The Road to Licensure and Beyond

The Road to Licensure and Beyond
Sample Graphic Vignette Problems

Evaluating Your Sample Solutions

Sample Problem 3
Solution 4 of 12

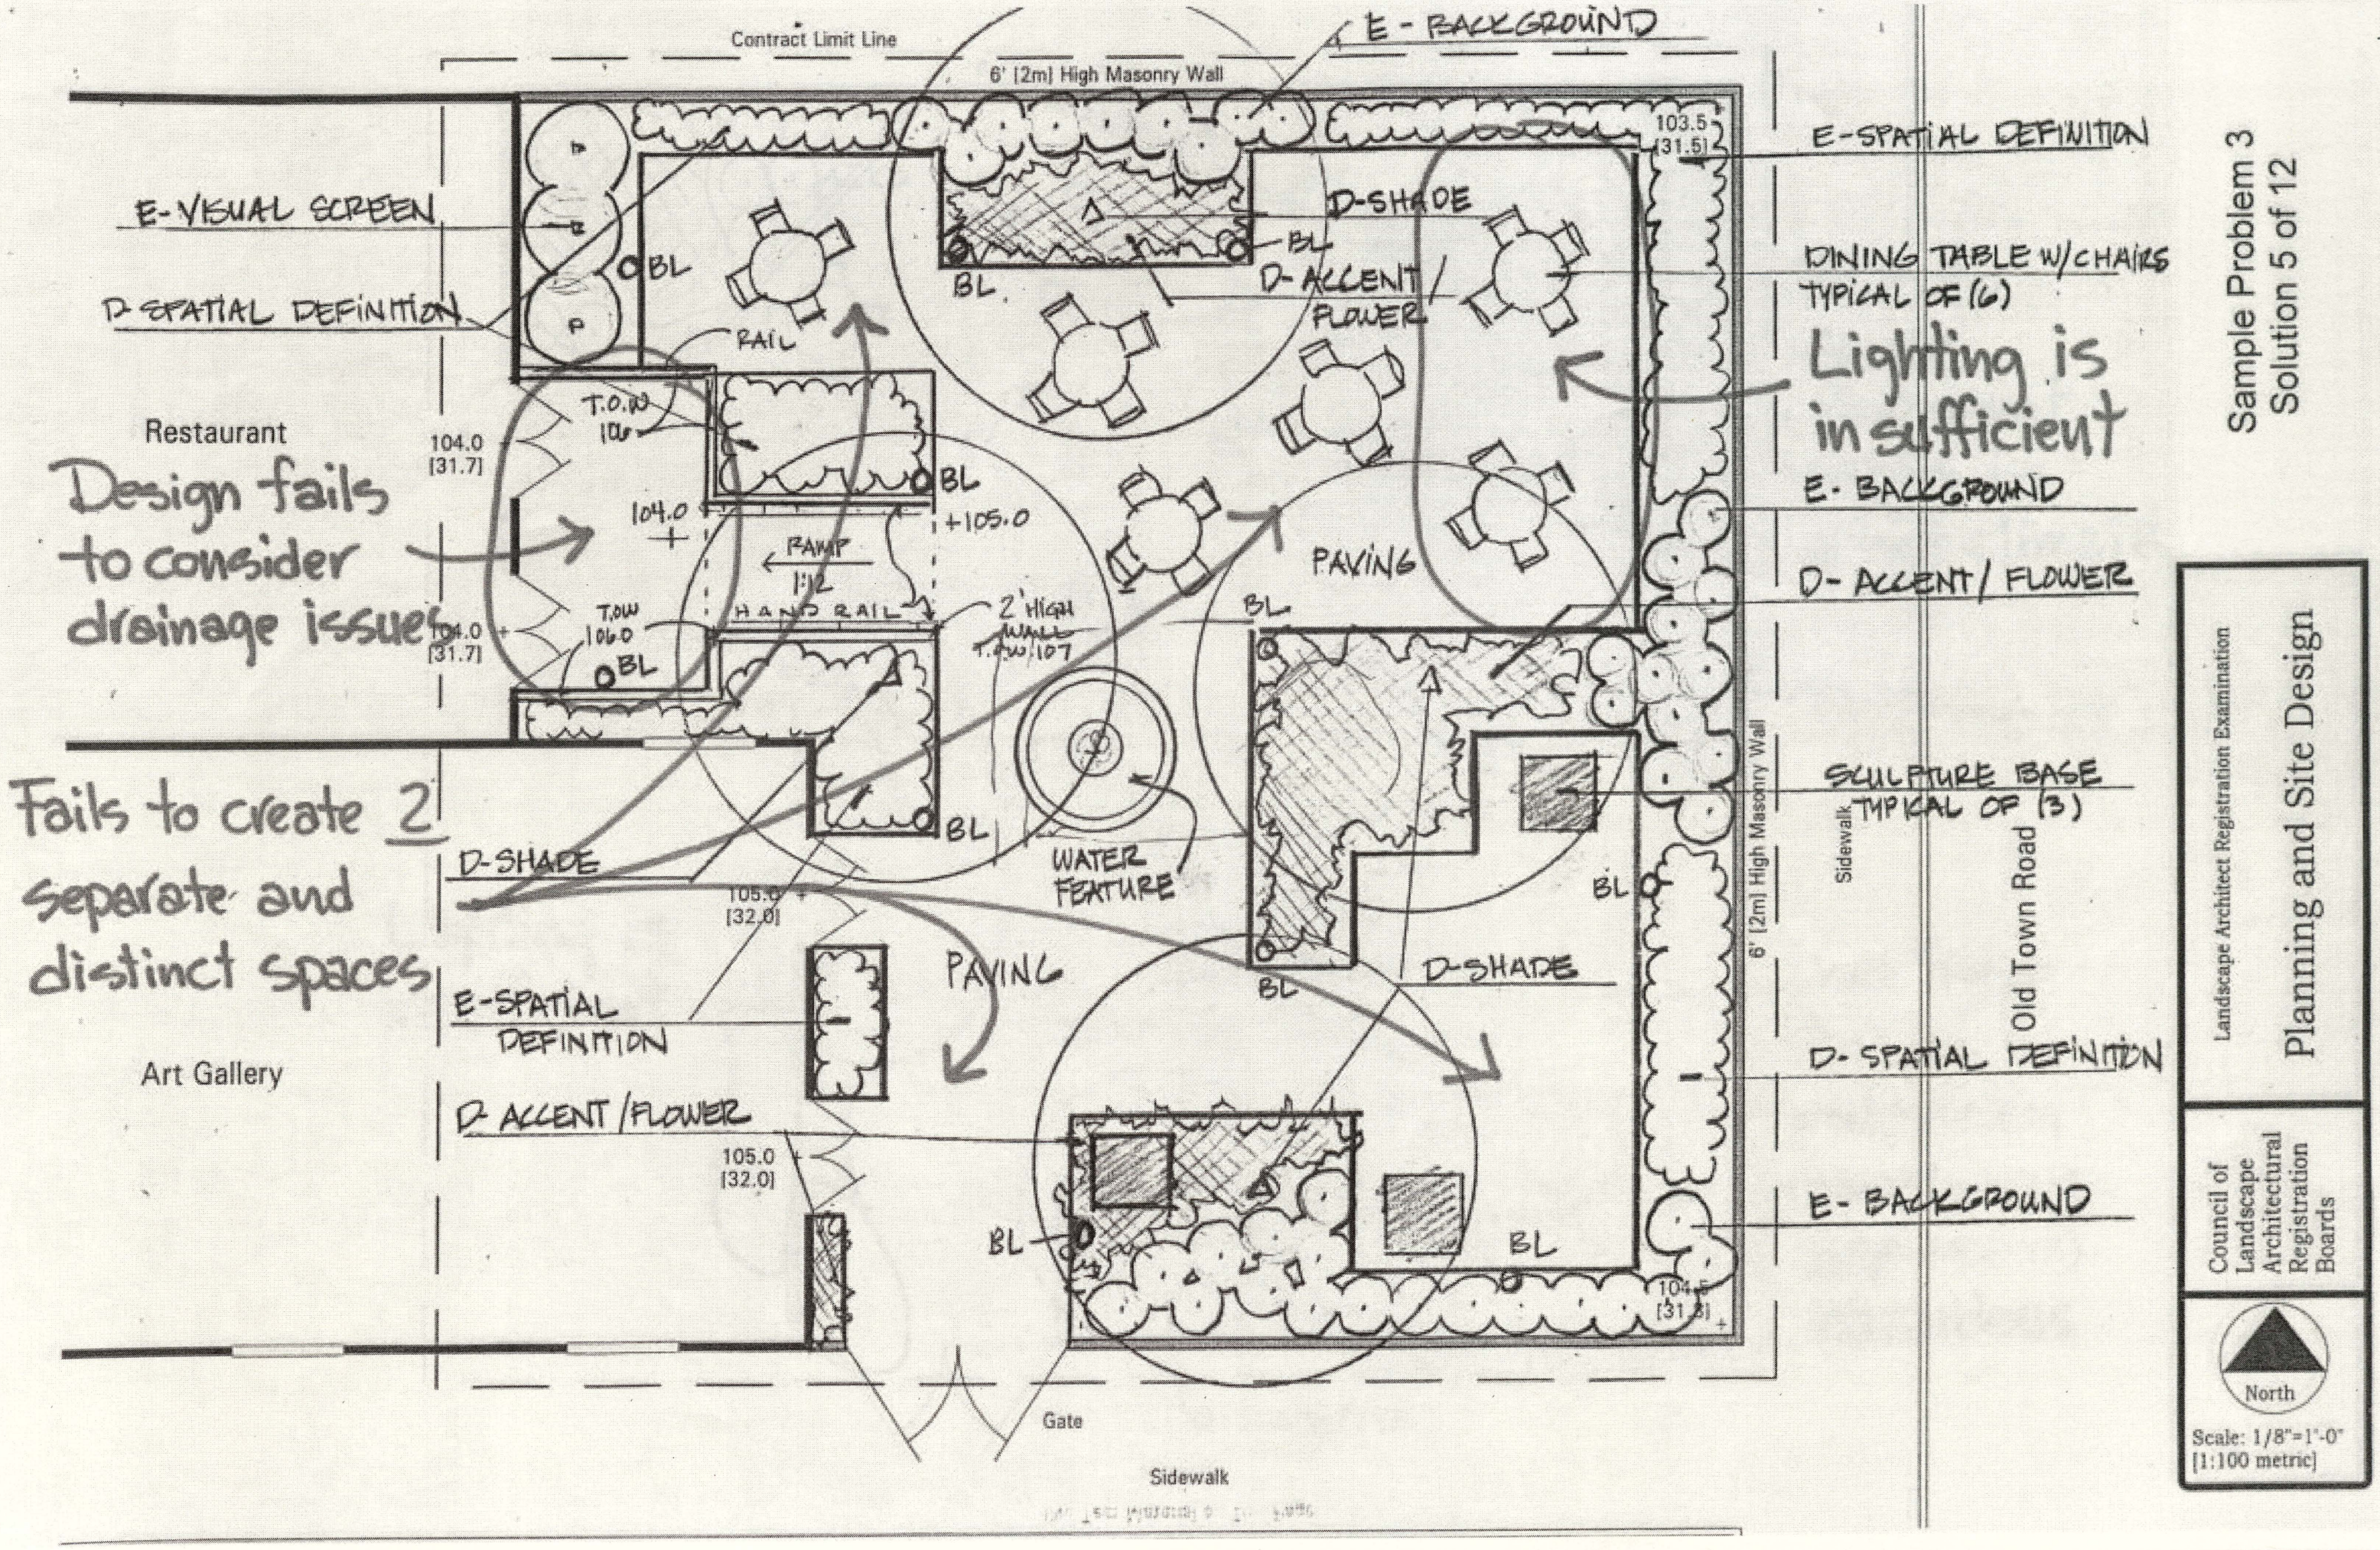
Symbol indicates a 30' canopy which would cover the light fixture making illumination inadequate

Fails to provide symbols per Reference Manual Requirements

Sample Problem 3
Solution 6 of 12

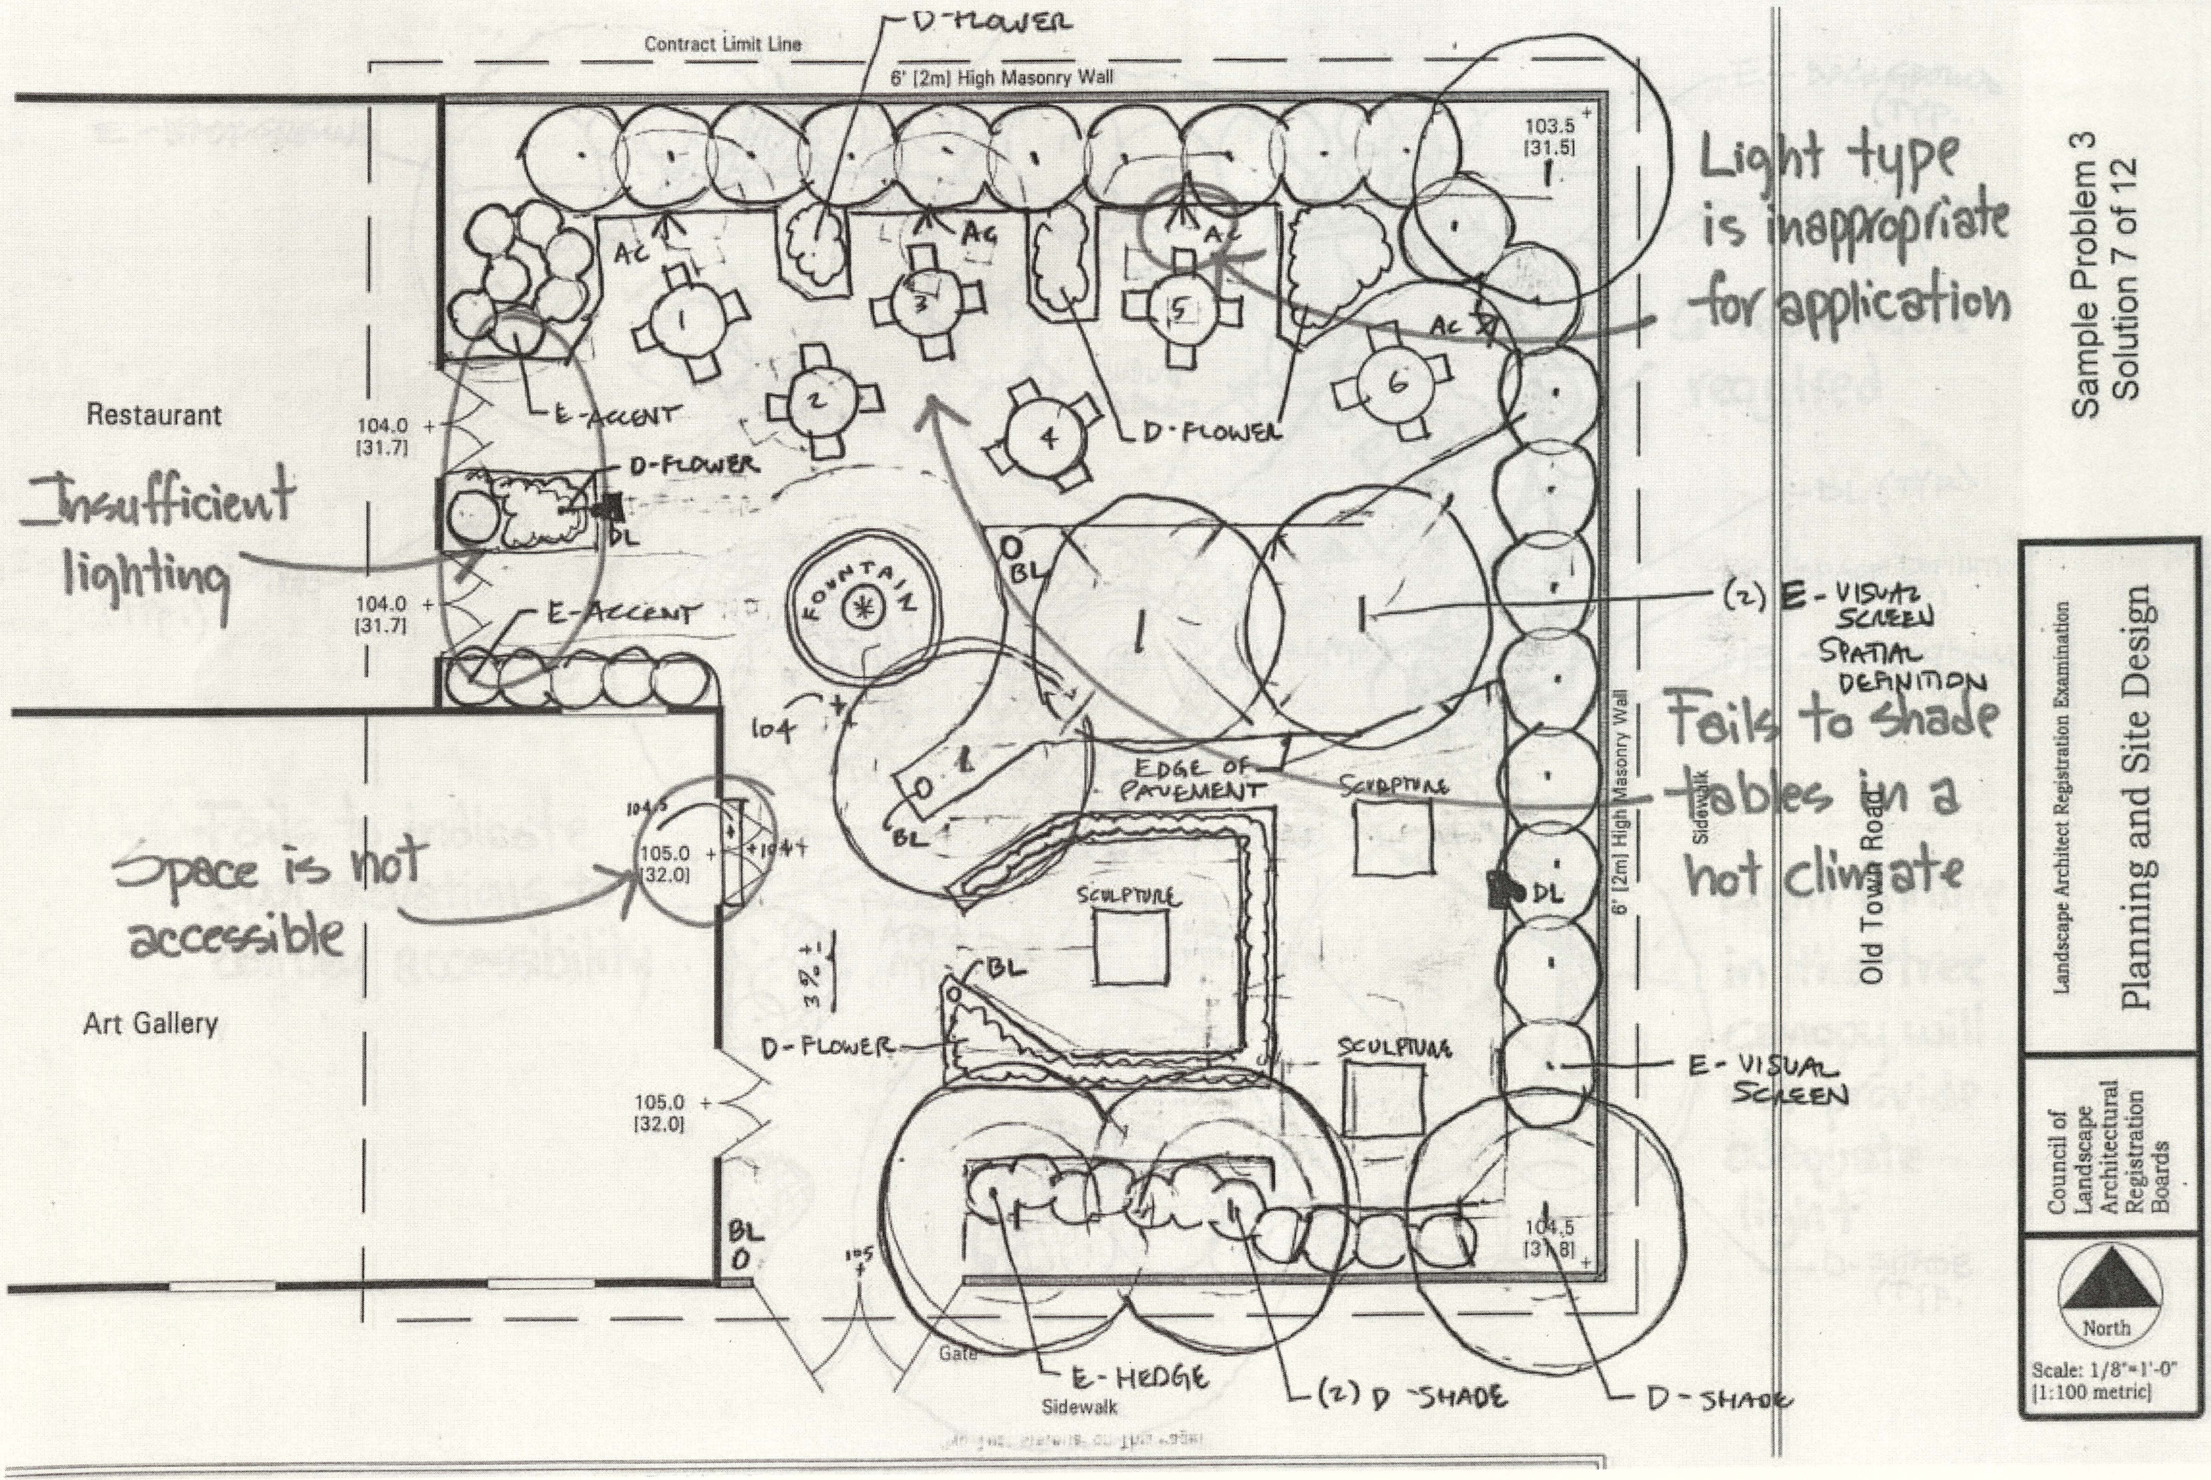
Fails to Shade restaurant tables in a hot climate

Lighting is insufficient

Low light fixtures in pedestrian travelways are hazardous
